To: Design Review Board
From: Tony Leavitt, Associate Planner
Date: May 23, 2013
File No.: DRV13-00254
Subject: **JUANITA BAY VETERINARY HOSPITAL AND OFFICE BUILDING
DESIGN RESPONSE CONFERENCE**

**JUANITA BAY VET/ OFFICE
DESIGN REVIEW
DRV13-00254**

DESIGN REVIEW BOARD

1 SITE SECTION
NOT TO SCALE

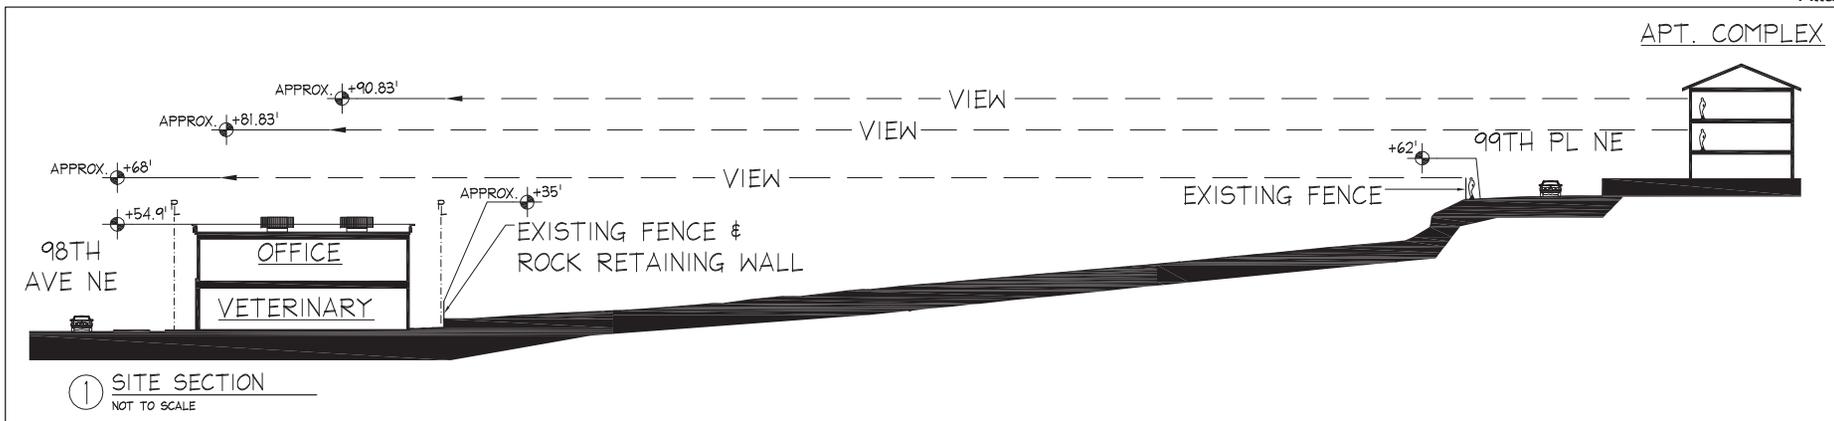
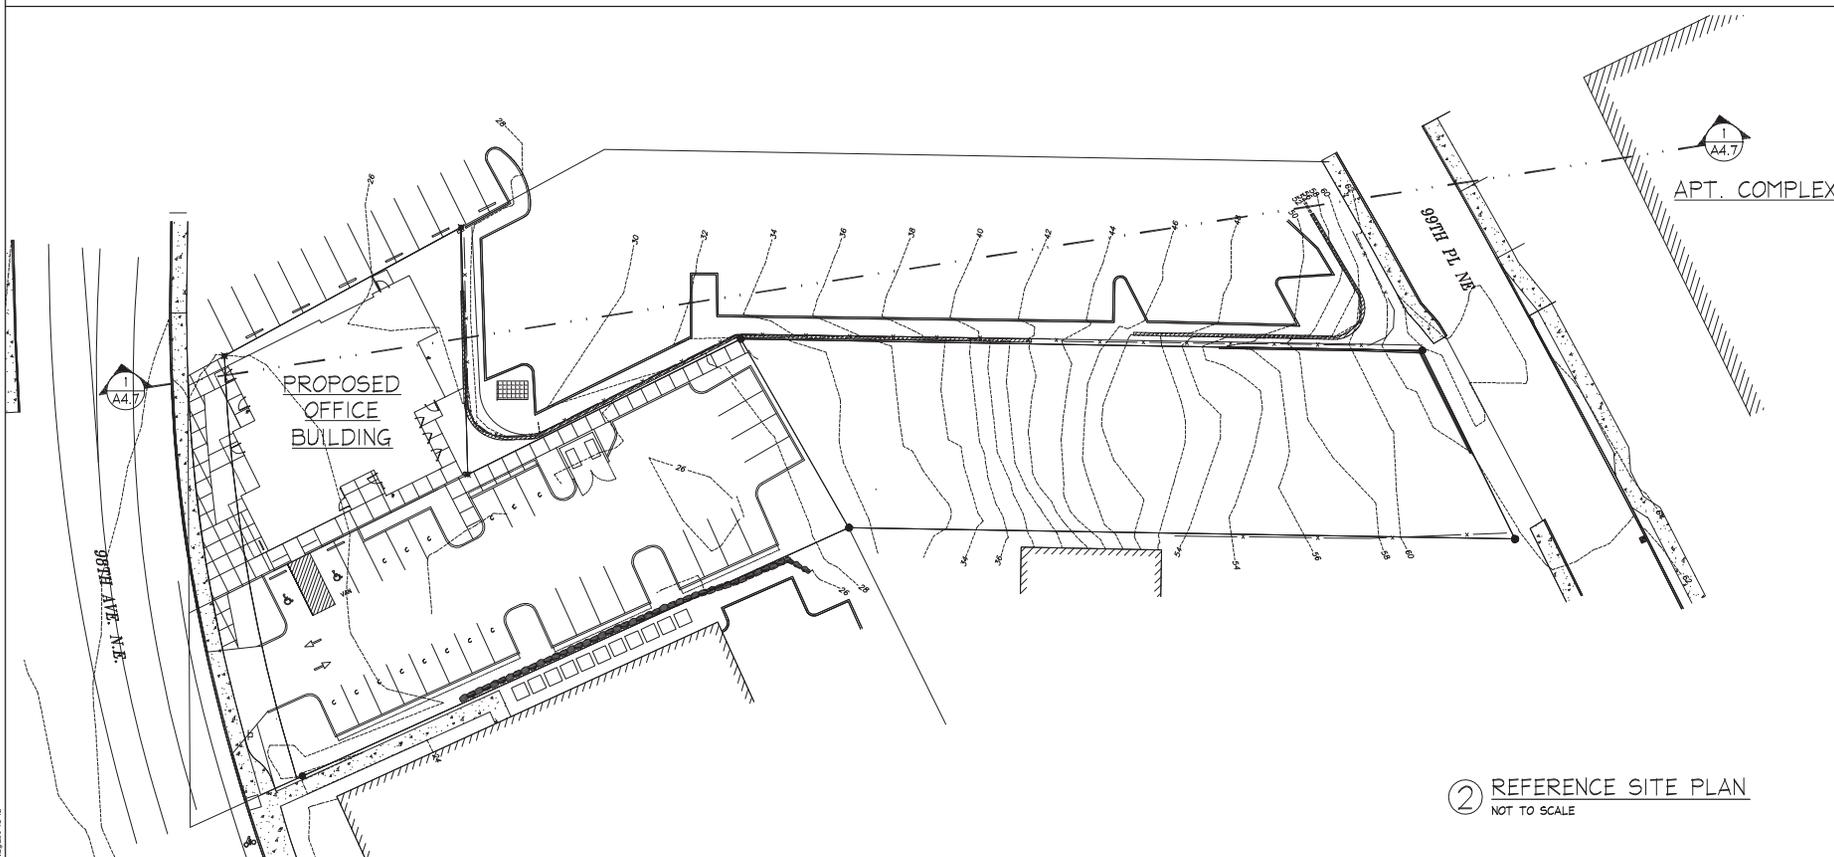
- Section drawings of the proposed building and adjacent buildings from 99th Place and 98th Avenue.
- Details of the north, west and south facades of the building visible from 98th Avenue and pedestrian space along the front façade.
- Relationship of proposal to adjoining off-site parking and other improvements. The DRB indicated that the design needed to resolve massing, façade treatment, and landscaping on all sides, regardless of existing encroachments.

1. **Section drawing of the project site and adjacent sites from 99th Place to 98th Ave NE:** *Requested site section is shown on sheet A4.7*
2. **Details of the north, west and south facades of the building visible from 98th Ave. Pedestrian spaces on front façade. Provide options to avoid blank façade on north side. What architectural treatments will be used to avoid a blank façade on the north side?:** *Please refer to elevation and three dimensional model renderings shown on sheet A4.1, A4.3 & A4.5. We have utilized a variety of techniques to address blank wall concerns including changes in the physical plane of the wall, transparency (windows), and changes in both texture and materials. We have as well utilized a darker material color at the wall recess to emphasize and strengthen the perceived depth while minimizing the perceived length of the overall north wall. Stair stepped west elevation adds interest for south bound pedestrians and vehicular traffic, and the accent color at the recess was selected to compliment the earth tone reds and browns that exist on the adjoining structures to the north.*

SHEET TITLE:
**BUILDING
DETAILS**
DESIGN REVIEW BOARD
SHEET NUMBER:

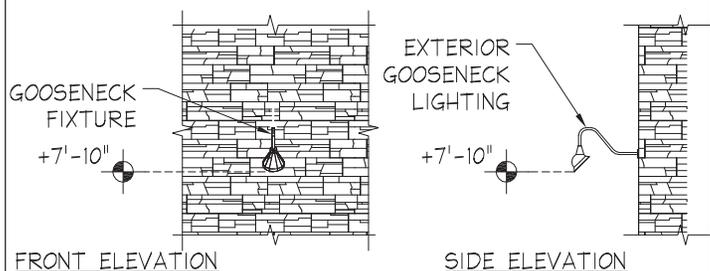
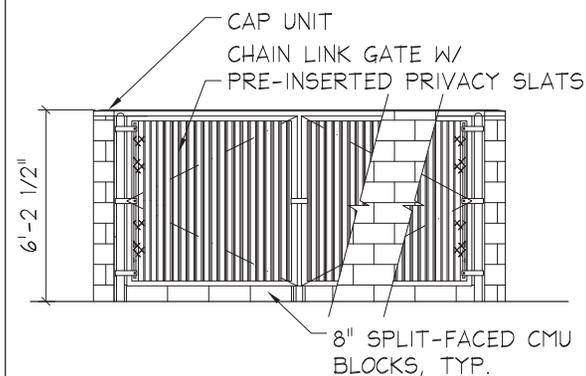
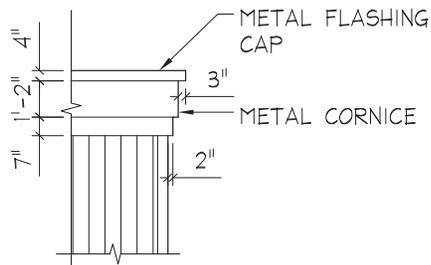
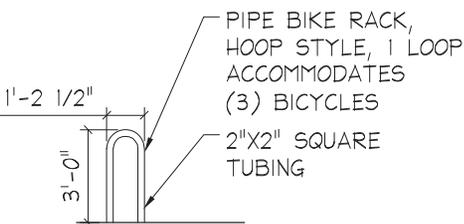
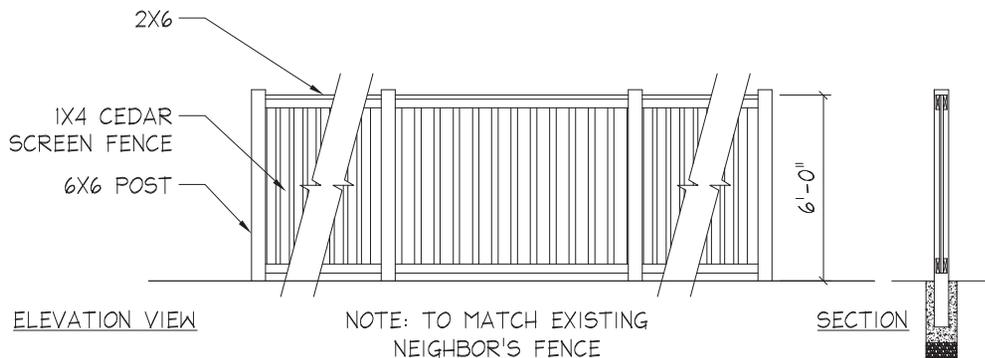
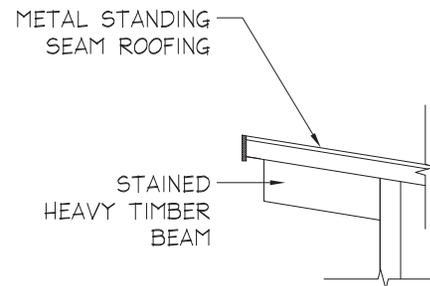
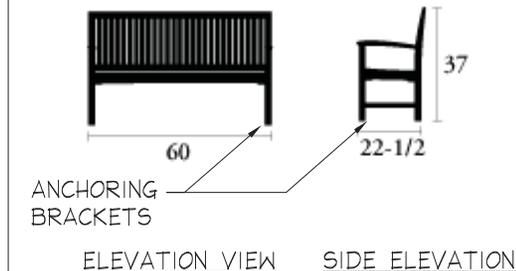
The DRB requested building material and lighting details, including a roof plan with showing integrated rooftop screening, and the preliminary signage concept.

5. **Building materials and lighting details:** *Please refer to sheet A4.8. Major building materials include: dry stacked stone veneer, stucco, corrugated steel and metal canopies. Please refer to the material sample board for actual finish materials and colors.*
